Borrego Springs Watermaster

Technical Advisory Committee

October 16, 2024

TAC Comments on Draft Task 4 TM

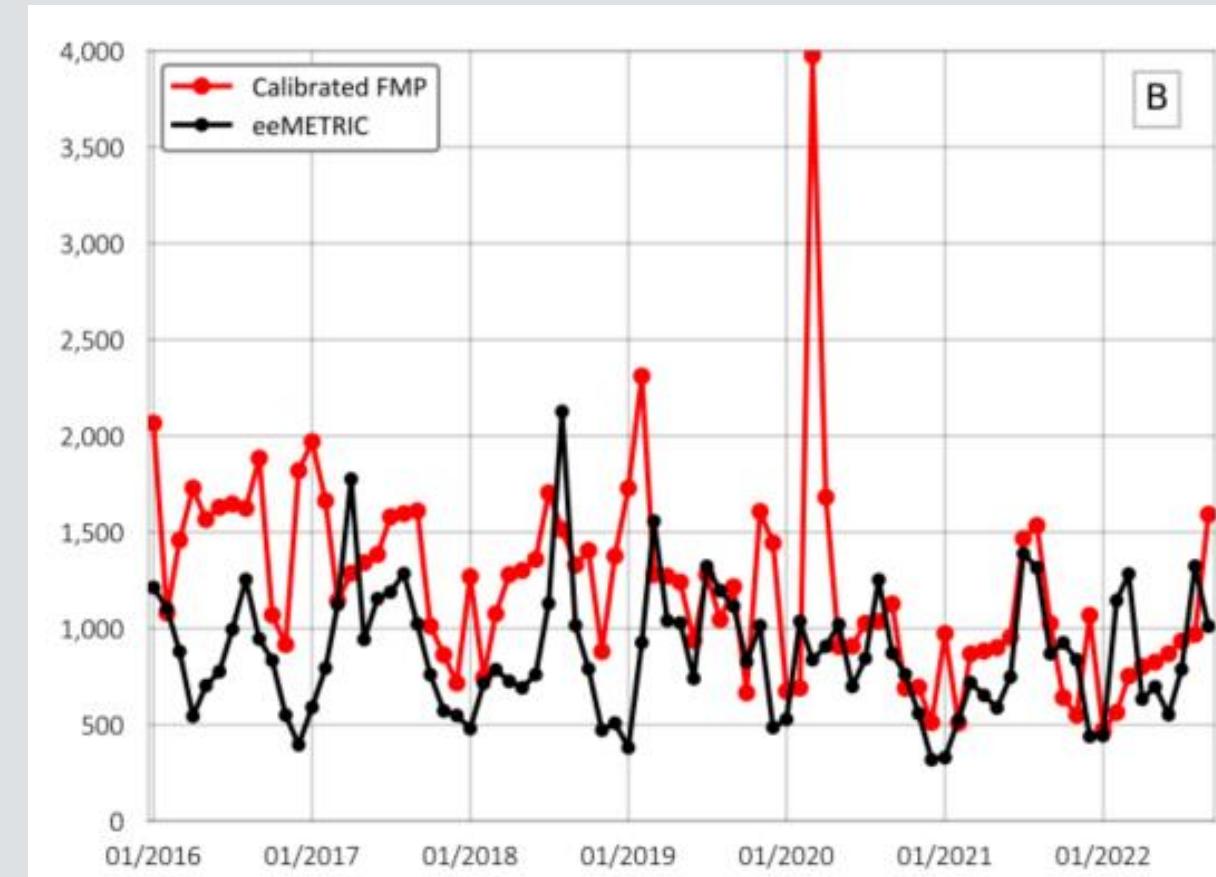
- **AAWARE comment on Table 3. FMP-Estimated Pumping vs. Actual Pumping:** “Why did the total metered pumping numbers change? According to Technical Memorandum dated March 15, 2024 Table 1, actual pumping was 12,857 AF in 2021 and 10,863 AF in 2022. See Appendix A”
- **Response to Comment:**
 - Pumping from State Park well no longer included in Actual Pumping
 - During Task 3, the State Park well was added and metered pumping data was assigned in the MNW2 package
 - Estimated pumping for two wells in WY 2021 was reduced during Water Rights Accounting Process
 - Pumping for these wells had previously been estimated using water duty method.
 - Metered data became available in WY 2022 and was used to revise the WY 2021 estimate of pumping.
 - Changes reduced Actual Pumping by 733 AF in WY 2021 and 15 AF WY 2022

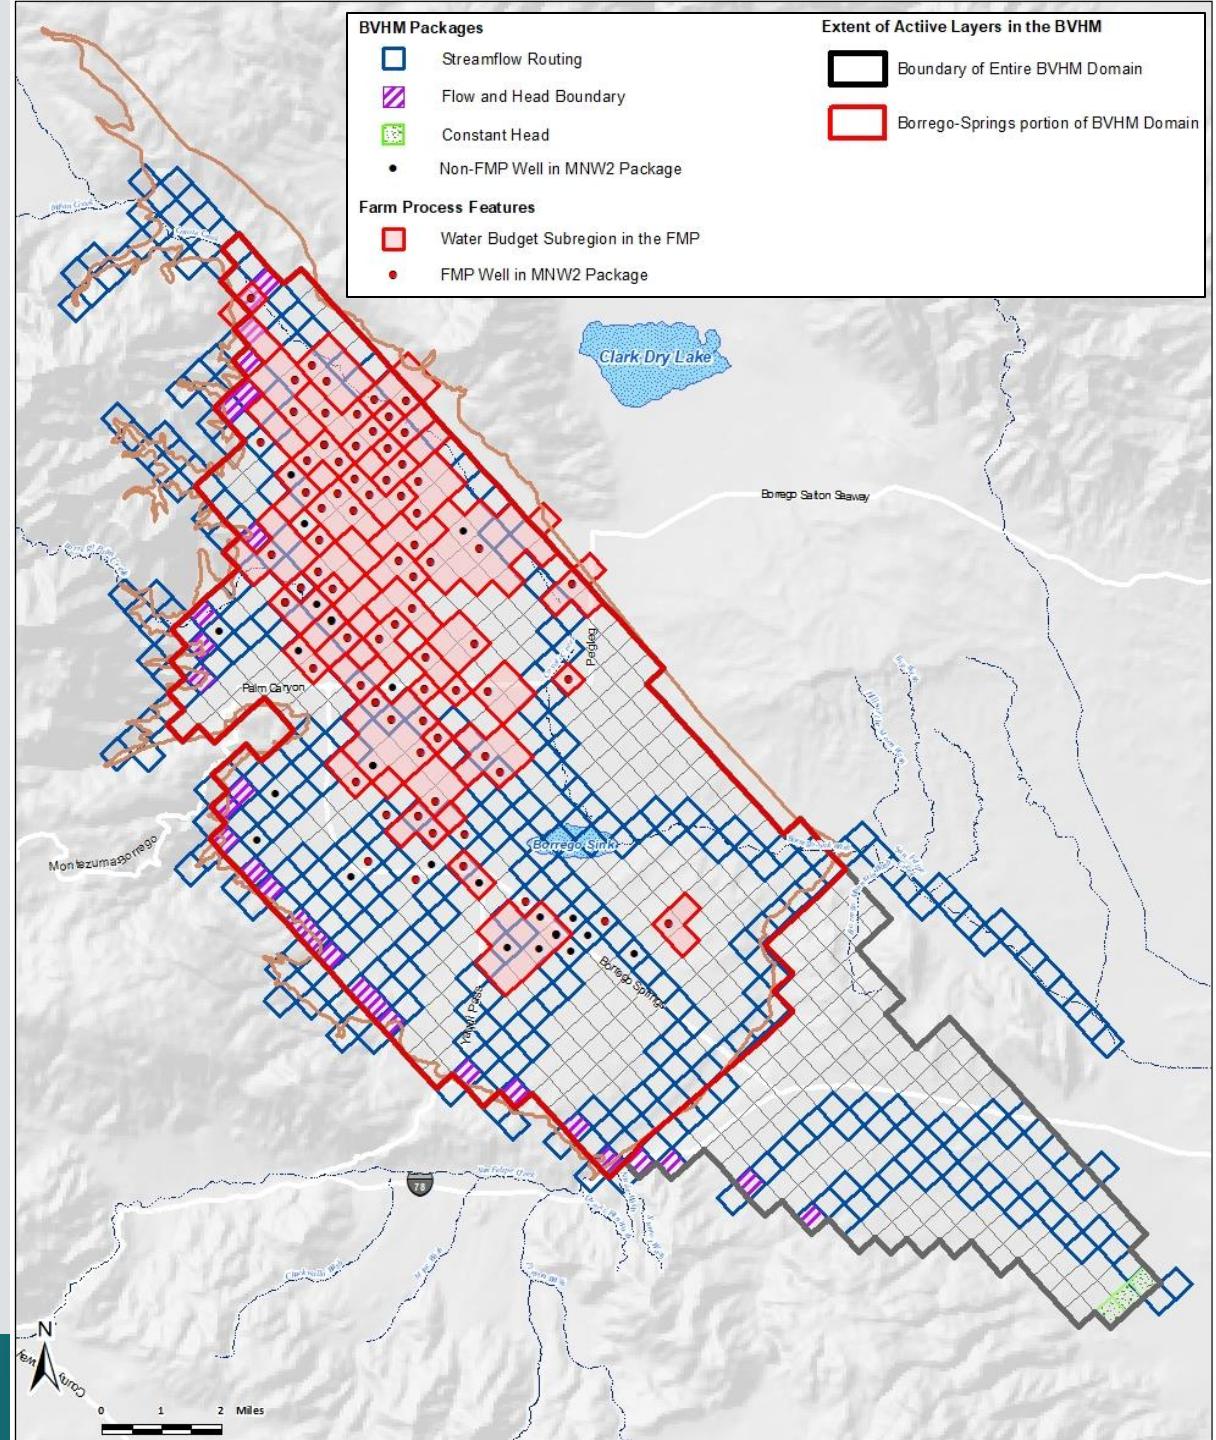
- **AAWARE:** Why did outflows from the model stay the same after excluding the portion of the model overlying Ocotillo Subbasin?
- **Response to Comment:**
 - Only two tables in the report present water budgets:
 - Table 2 - entire model domain of the *Pre-Calibrated BVHM*. Outflows = 14,057 afy
 - Table 6 - Basin-only portion of the *Calibrated BVHM*. Outflows = 17,192 afy
